Record of Executive Business and Chief Executive's Order

Reg. Reference:	SDZ21A/0014	Application Date:	03-Jun-2021
Submission Type:	Clarification of Additional Information	Registration Date:	25-Jan-2022
Correspondence Name and Address:	BMA Planning Taney Hall, Eglinton Terrace, Dundrum, Dublin 14		
Proposed Development:	<p>Development of 227 dwellings (24,513.8sq.m gross floor area); 95 3-bed, 2 storey terraced houses and associated gardens; 28 4-bed, 3 storey terraced houses and associated gardens; 48 3-bed, 2 storey duplex apartments over 48 2-bed apartments (3 storey buildings with 2 storey duplex over single level ground floor unit) and associated communal and private open space; 4 3-bed, 2 storey duplex apartments over 4 3-bed, 2 storey duplex apartments (4 storey buildings with 2 storey duplex over 2 storey duplex) and associated communal and private open space; all associated site and development works including roads, central public open space (0.12ha), car parking (361 spaces), bicycle parking (168 spaces), bin storage areas, 2 ESB substations (22sq.m), associated pedestrian footpaths and cycle paths, hard and soft landscaping and boundary treatment. A section of the East

The below image is an extract from the Adamstown Street Design Guide (ASDG) and indicates the typical layout of an avenue:

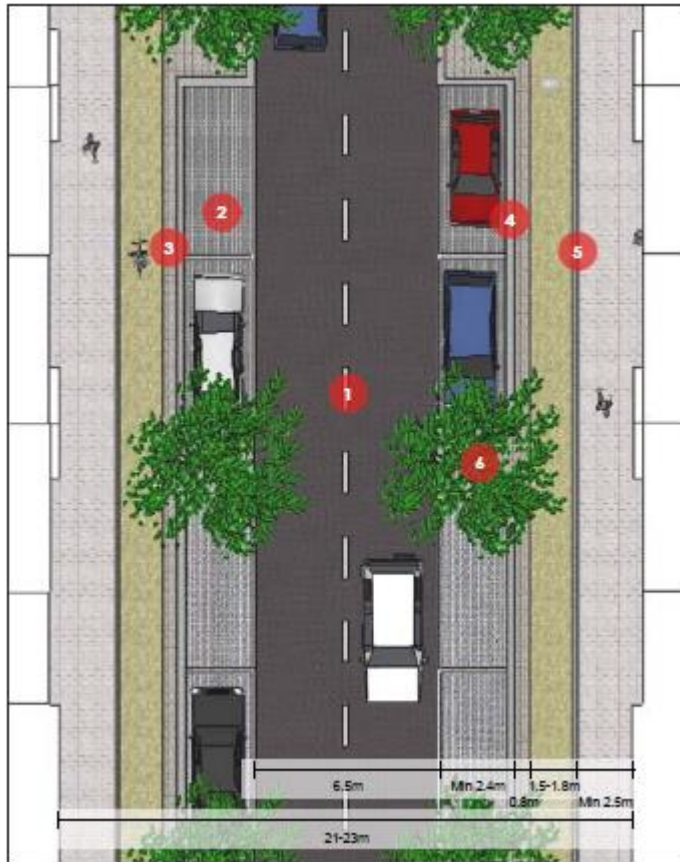
(1) The proposed 64 perpendicular in-curtilage car parking spaces located off Linear Park Road do not appear to be compliant with the Planning Scheme and the Roads Section have raised concerns in relation to traffic hazard. 'Linear Park Road' is identified in the planning scheme as an 'Avenue', the Adamstown Street Design Guide and the Planning Scheme defines as Avenue as:

Section 6.2 of the Design Guide gives clear guidance on how an Avenue should be designed and constructed. The applicant is requested to demonstrate how the proposed parking complies with the Planning Scheme and the Adamstown Street Design Guide and submit revised proposals to incorporate parallel parking provision along the eastern boundary of the subject site. The Planning Authority understands that this will significantly reduce the parking provision at this location but considers that as the proposed parking provision is at the maximum that is required there is scope to reduce car parking across the Phase 2 lands. Furthermore, there is scope to incorporate more parallel car-parking along the southern boundary at Adamstown Way, similar to the two spaces already proposed in the Parking Strategy.

1. The 'Linear Park Road' is consistent with the road hierarchy, as classified in Section 2.3.23 of the planning scheme, and illustrated on Figure 2.10. Roads and streets have been designed in accordance with DMURS, the 'Adamstown Street Design Guide' (ASDG) and in consultation with SDCC Roads Department. ASDG is an evolving document, allowing for new typologies and standards.

The Roads Department has raised no objections to the Applicant's response to Item 1(4) and has stated *“Junction radii have been amended. Drawings of the sightlines have been submitted. The kerb transitions have been altered to omit the protruding kerb”*.
